IEEE 802.3cg
PLCA Status Reporting
August 15th, 2018

Proposed Text Changes

Figure 148-4—PLCA Control state diagram (1 of 2)

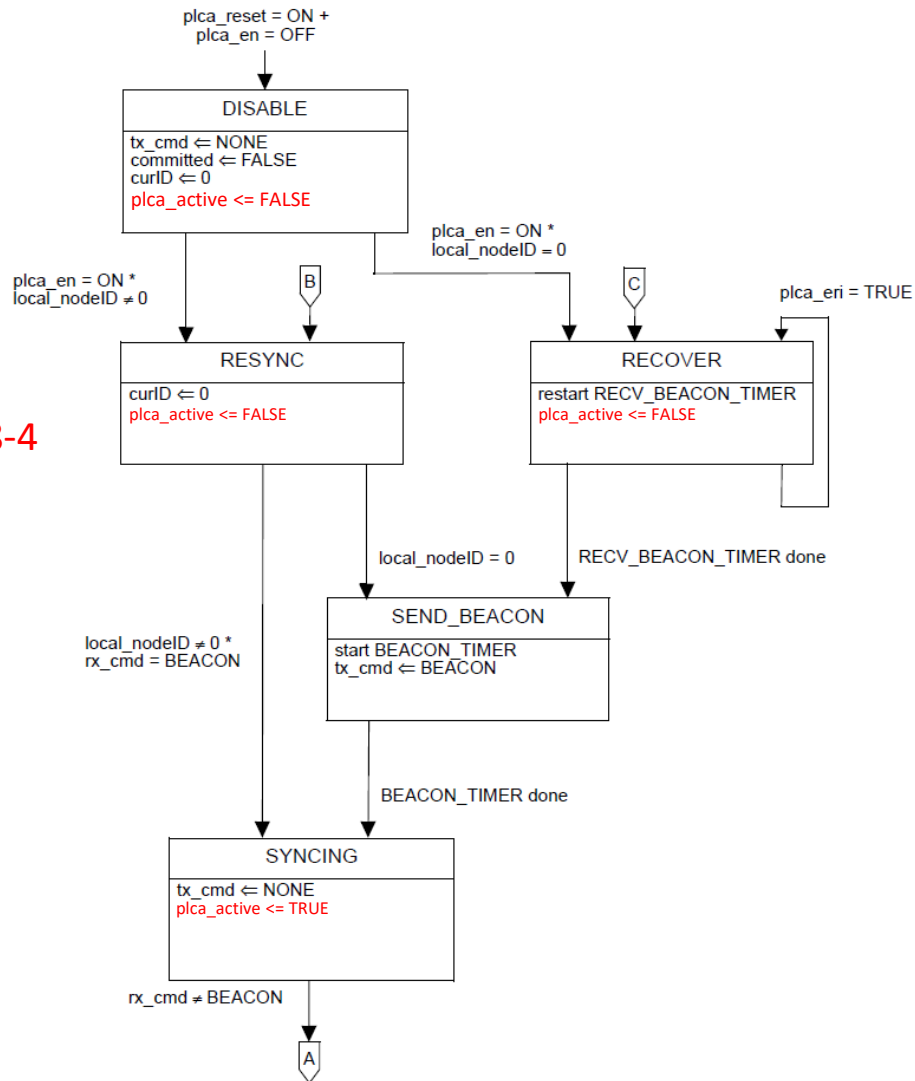
- 148.4.5.2 PLCA Control variables

`plca_active`

notifies the PLCA Status function whether the node is waiting for sending or receiving a BEACON or it already sent or received one.

MODIFY
FIGURE 148-4

Figure 148-TBD PLCA Status state diagram

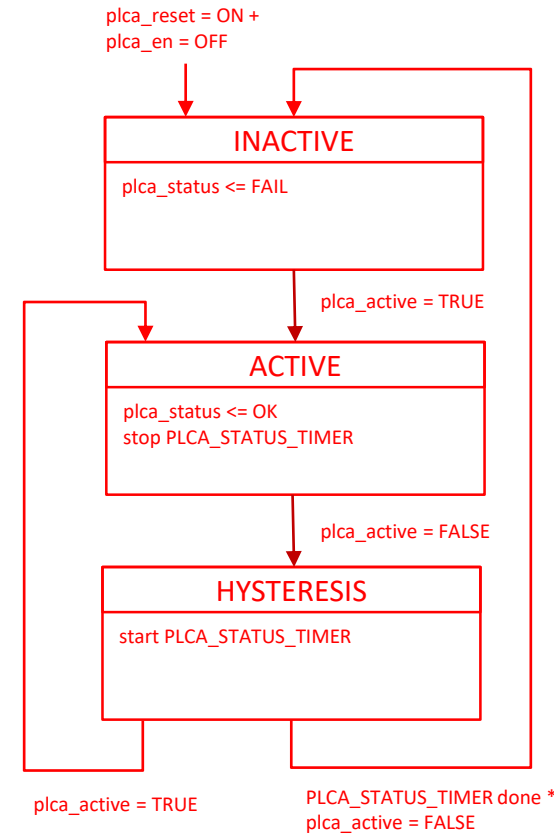
- 148.4.7 PLCA Status
- 148.4.7.1 PLCA Status State Diagram

PLCA Status State Diagram is responsible for reporting whether nodes are actively sending / receiving the BEACON.

The PLCA Status function shall conform to the PLCA Status state diagram in Figure 148-TBD and associated state variables, functions, timers and messages.

Upon reset or when PLCA is disabled, PLCA Status function enters “INACTIVE” state and reports `plca_status` as “FAIL”. As soon as the PLCA Control function enters the SYNCING state (i.e. receiving or transmitting the BEACON), `plca_active` variable is set to TRUE and PLCA Status switches to ACTIVE state, reporting `plca_status` as “OK”.

From “ACTIVE” state, whenever `plca_active` is set to FALSE by PLCA Control function, the PLCA Status function enters “HYSTERESIS” state, still reporting `plca_status` as “OK” and arming `PLCA_STATUS_TIMER`.

If `plca_active` is reset to TRUE, then PLCA Status reverts to “ACTIVE” state, effectively filtering the momentarily inactive state. Instead, if `PLCA_STATUS_TIMER` expires while `plca_active` is still FALSE, the PLCA Status function reverts to “INACTIVE” state, reporting `plca_status` as “FAIL”.

ADD
FIGURE 148-TBD
IN CLAUSE 148.4.7
